## CDM: Recommendation Form for Small Scale Methodologies (version 01)

<b>Date of SSC WG meeting:</b>	21–24 September 2009, SSC WG 22
<b>Title/Subject (give a small title or specify the subject of your submission, maximum 200 characters):</b>	Revision of AMS-III.Q to include project activity involving enhanced waste heat recovery
<b>Indicative methodology to which your submission relates (refer the items of Appendix B of the Simplified Modalities and Procedures), if applicable.</b>	AMS-III.Q, version 2
<b>Name of the authors of the query:</b>	Kunal Sharma Institution: ICF International <a href="mailto:ksharma@icfi.com">ksharma@icfi.com</a>

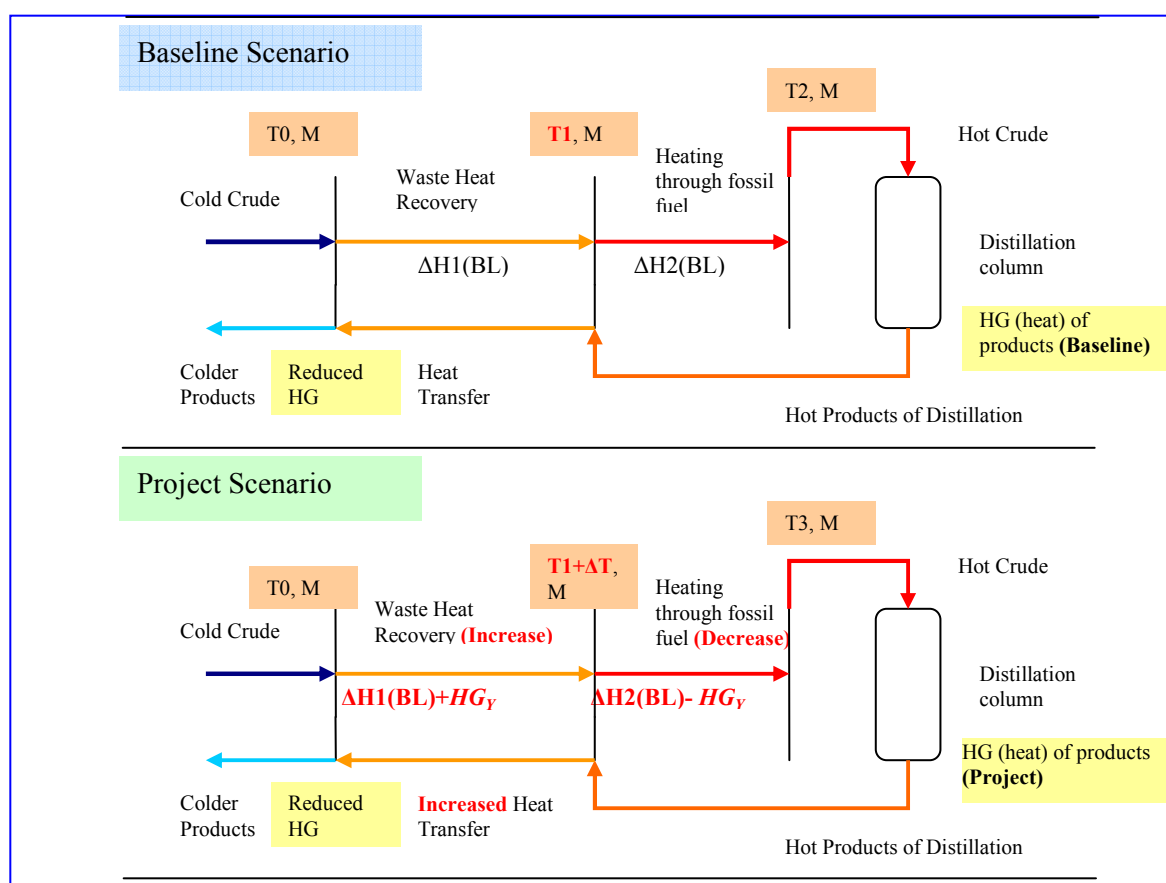
- b. Associated changes in the applicability conditions have also been introduced.
2. The following picture depicts the situation being referred to:

3. **Description of above picture:** The baseline emissions correspond to the emissions that would have happened in the absence of the project activity to heat the colder fluid using fossil fuel to produce the heat:  $HG_Y$ . This heat ( $HG_Y$ ) is being produced during the project activity using waste heat. The waste heat transferred is quantified by calculating the increase in the enthalpy of the media heated by the increased waste heat recovery process. In the project scenario due to installation of additional waste heat recovery equipment - the Waste Heat Carrying Medium (WECM) results into heating of cold crude to higher temperature ( $T_1 + \Delta T$ : referred to as  $T_{Project,y}$  in the methodology) than what would have happened in the baseline ( $T_1$ : referred to as  $T_{Baseline}$  in the methodology).

3. It is unclear whether all the cold and hot streams going to the HEN and coming from the HEN are exactly the same (same mass flow, same inlet/outlet temperature) in the baseline and the project situation or to which extent there are differences. For example, a certain hot stream may only be used in the project activity and not in the baseline or vice versa. However, this may impact energy consumption / emissions outside the project boundary and should therefore not be neglected. Therefore applicability conditions should be added regarding the four different stream types entering and leaving the HEN / HECE system viz. the cold stream input, output, hot stream input and output.
